BID ADDENDUM NO. 3

CONSTRUCTION NEW GEORGE WYTHE HIGH SCHOOL (RHSA)

**IFB # 23 – 7061 – 11
RRMM Project # 21310 – 00**

**January 4, 2024
Architect of Record:
RRMM, Architects, PC
1317 Executive Boulevard
Suite 200
Chesapeake, VA 23320
Phone: 757-213-6350**

FIRST FLOOR PLAN - AREA 'F' - POWER

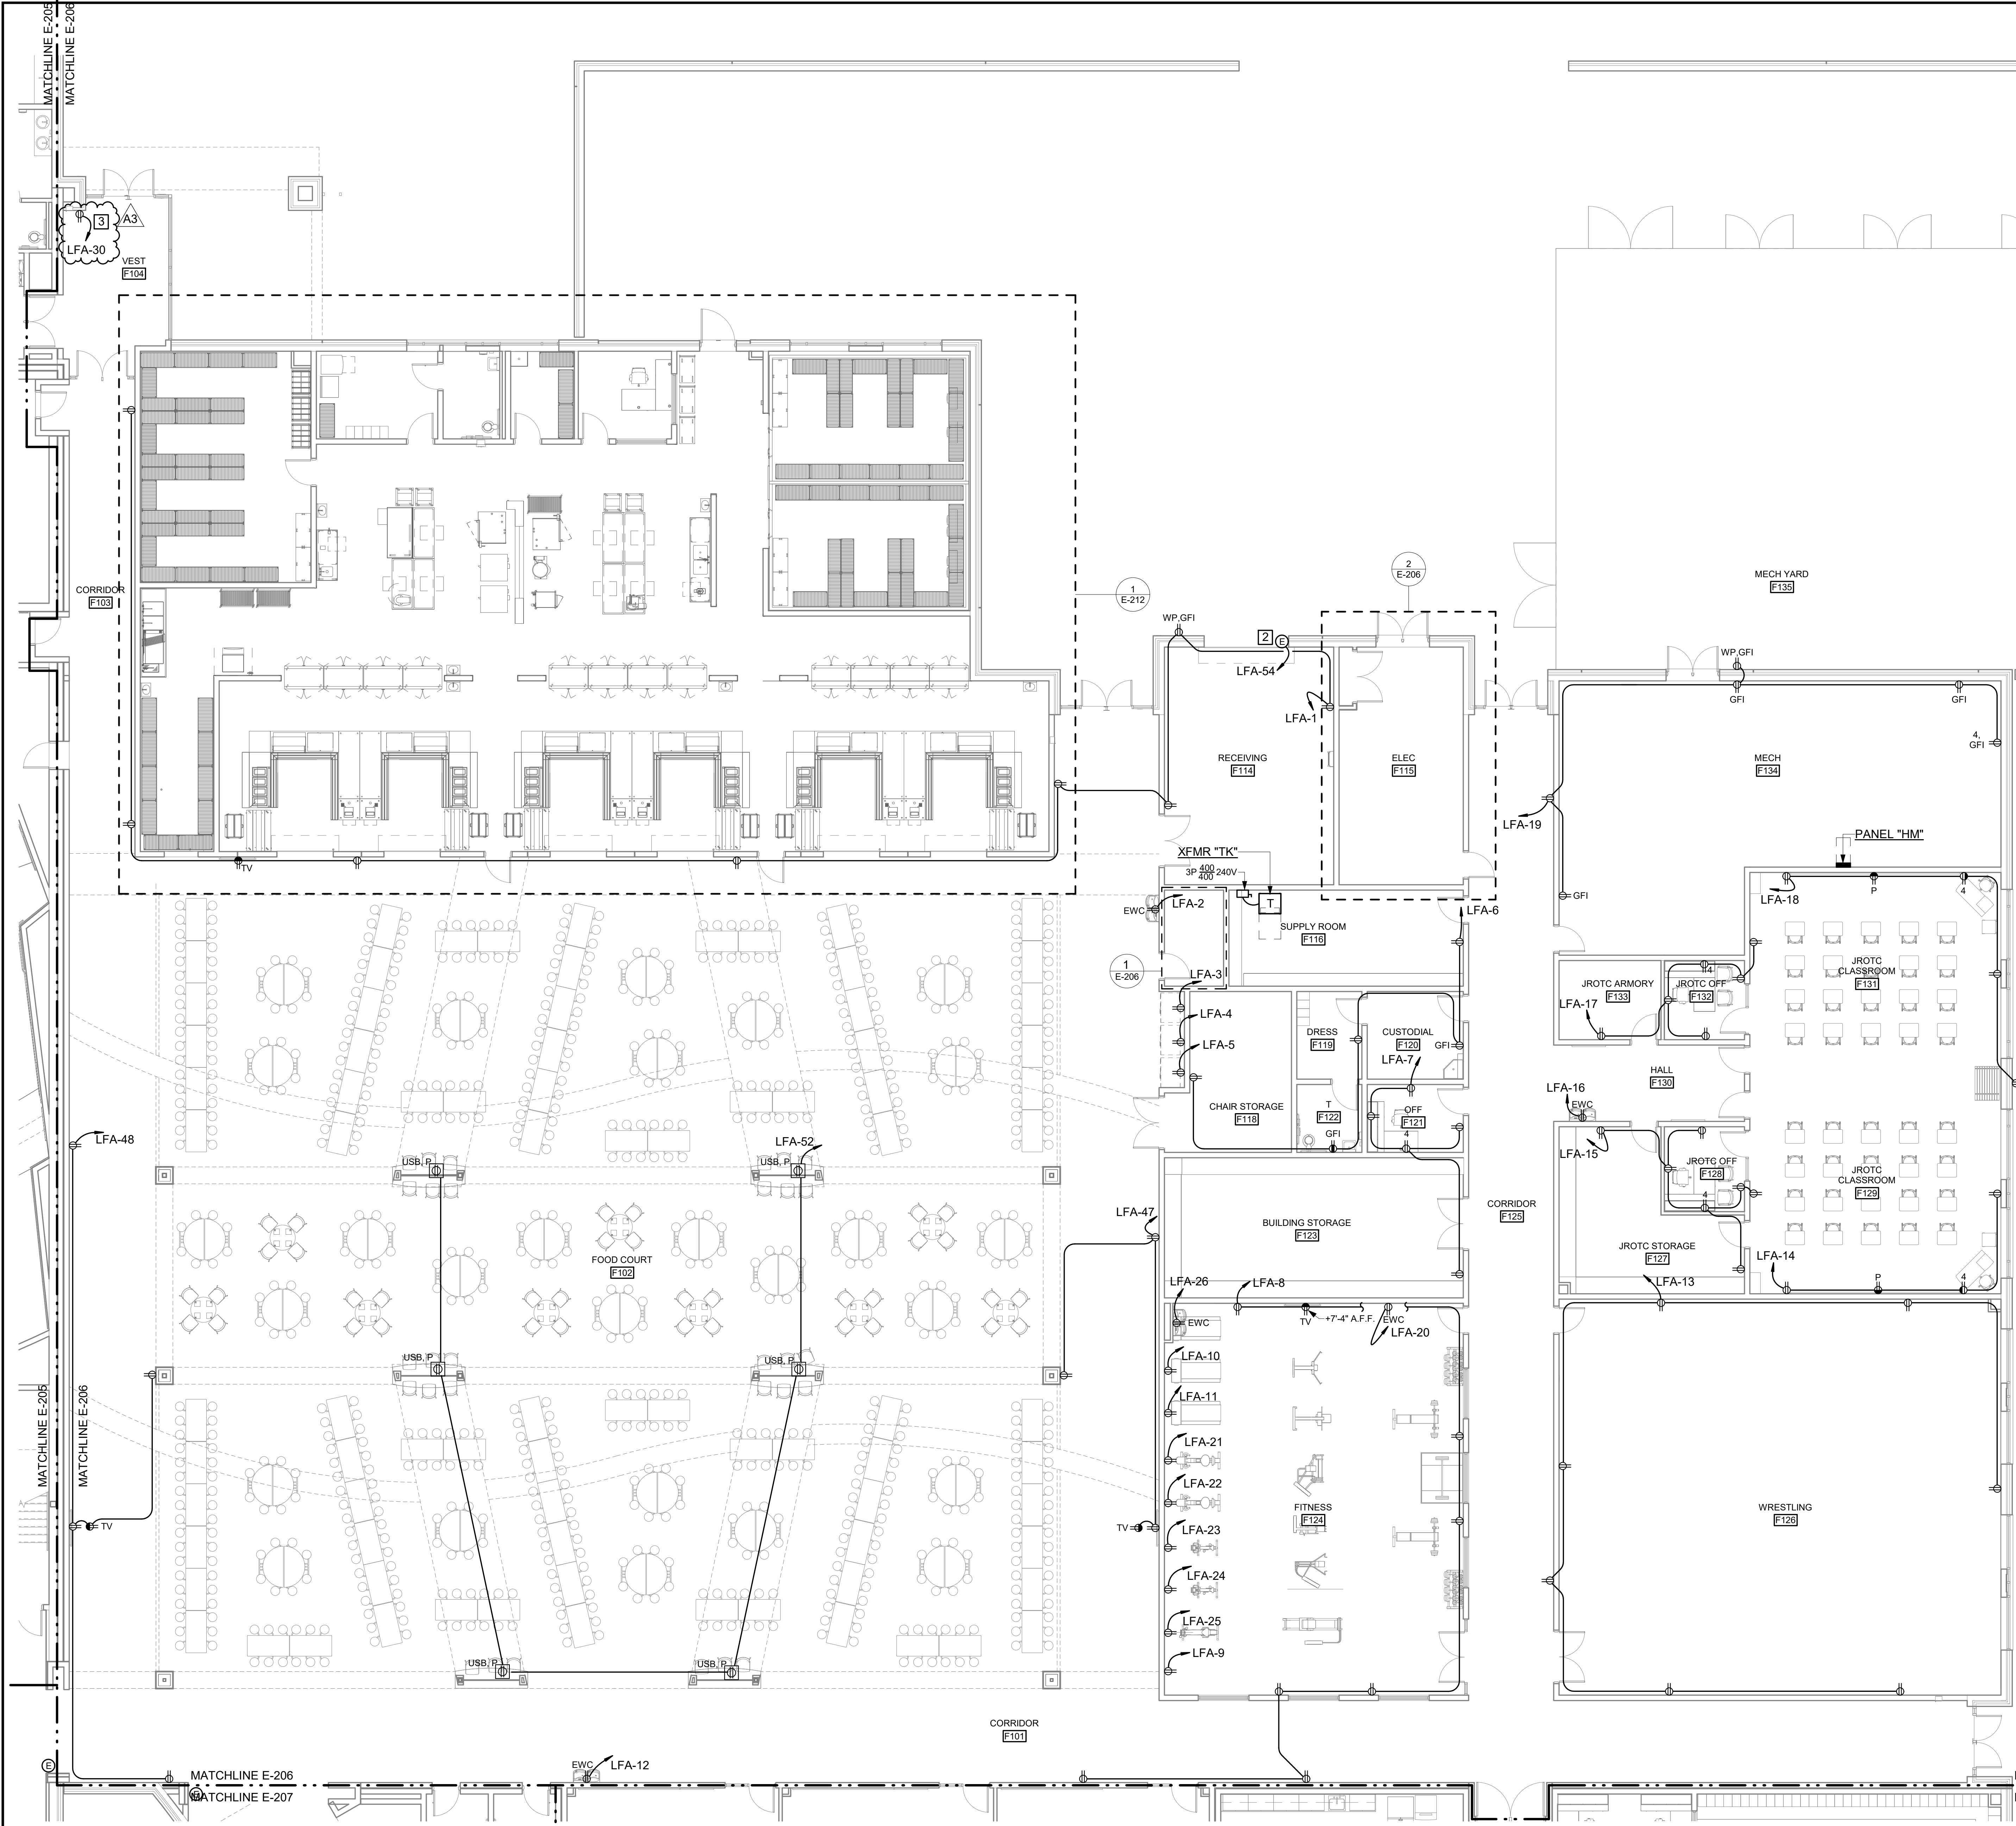
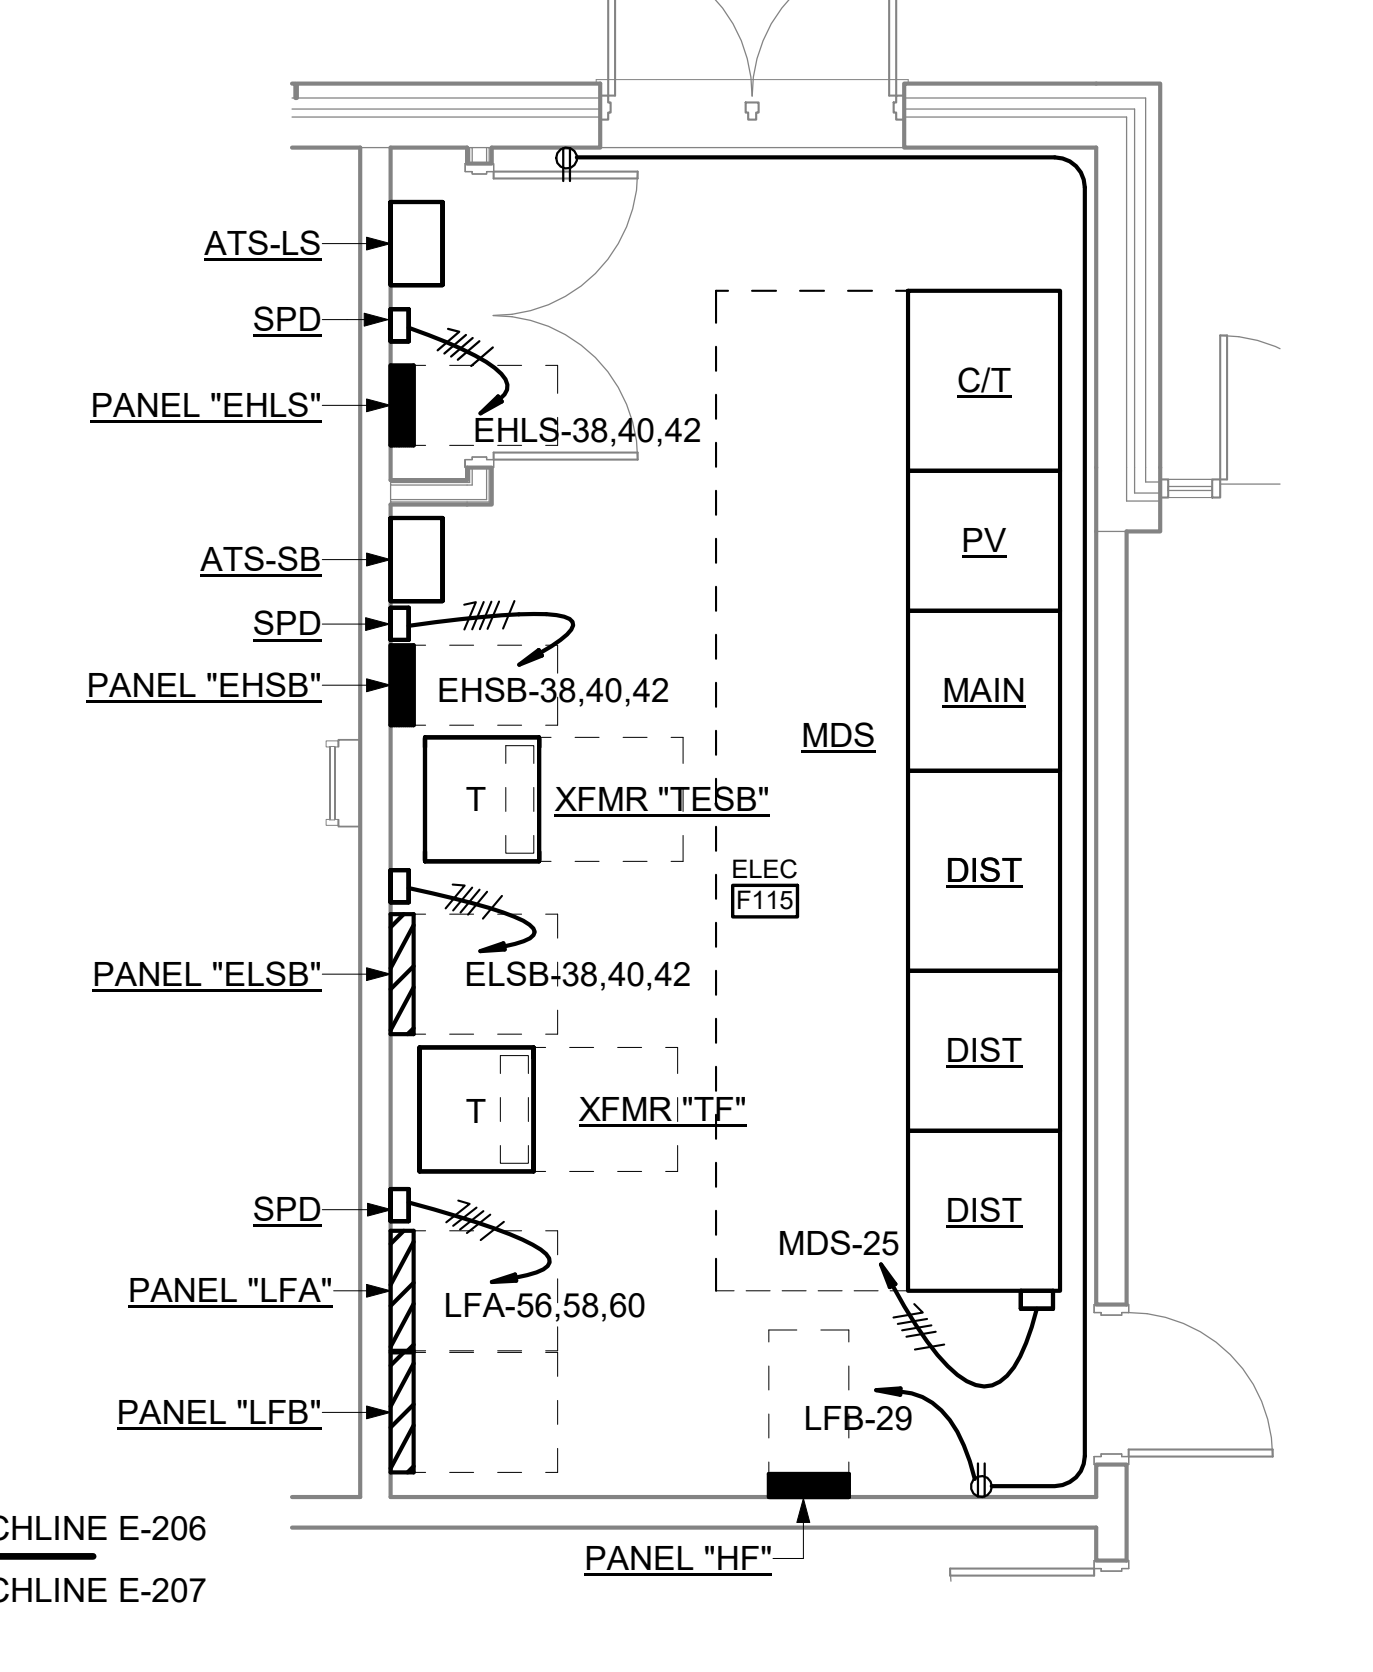
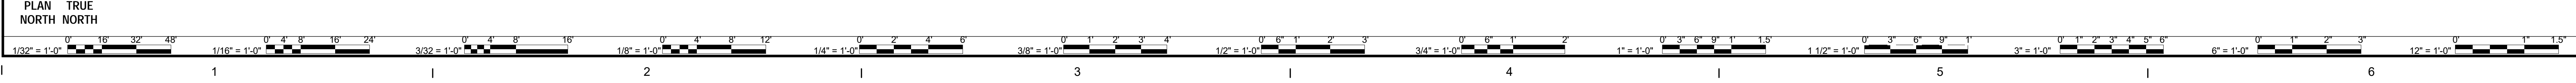
3.23 SHEET E-206 - FIRST FLOOR PLAN – AREA ‘F’ – POWER:

- First Floor Plan – Area ‘F’ – Power – **ADD** keynote 3 to vestibules F104 per the attached revised sheet.
- Construction Notes – **ADD** Keynote 3 per the attached revised sheet.

POWER RISER DIAGRAM

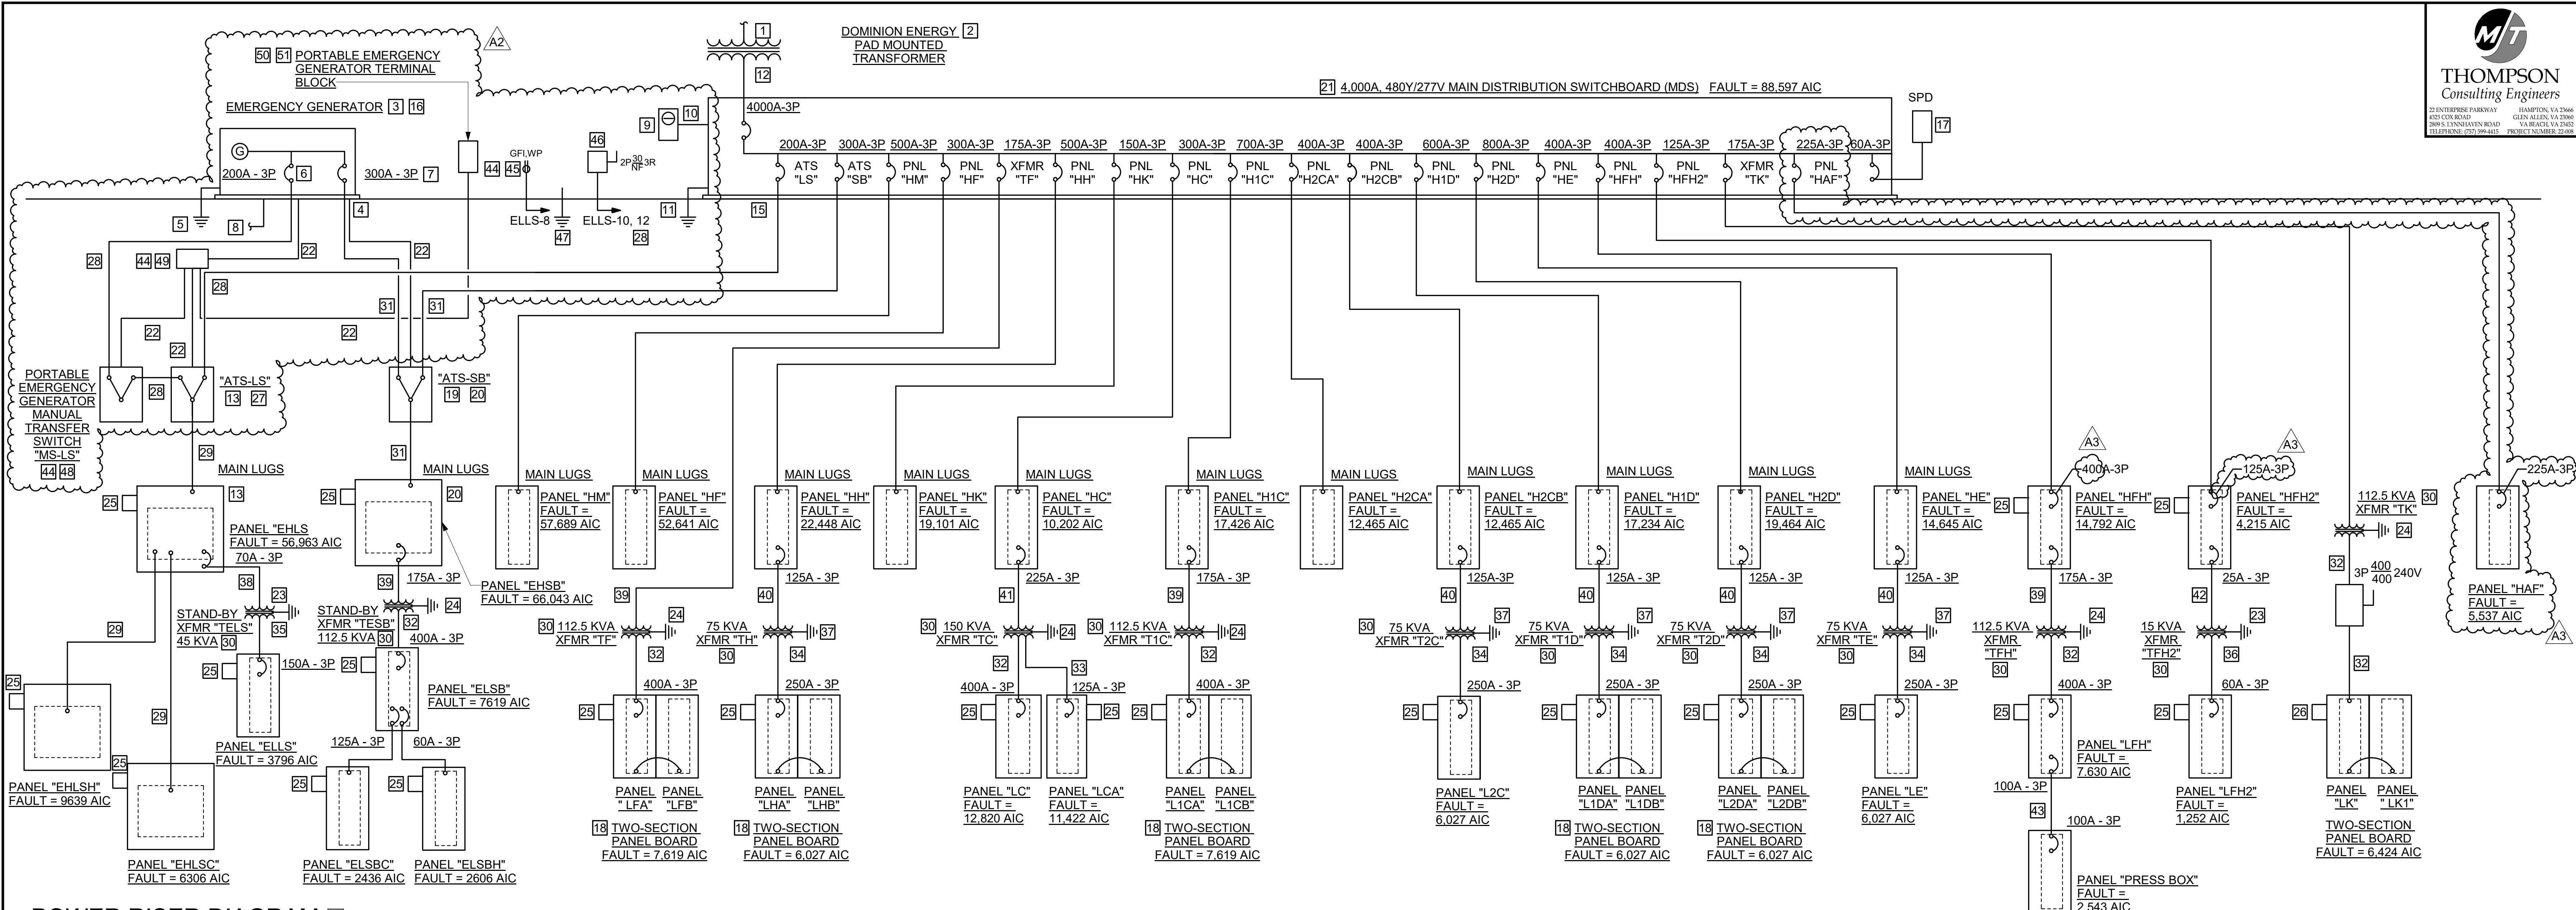
3.25 SHEET E-601 - RISER DIAGRAM:

- POWER RISER DIAGRAM - **REVISE** circuit breaker size for panel **HFH** per the attached revised sheet.
- RISER DIAGRAM NOTES - **ADD** circuit breaker size for panel **HFH2** per the attached revised sheet.
- RISER DIAGRAM NOTES - **ADD** circuit breaker and feeder for panel **HAF** per the attached revised sheet.
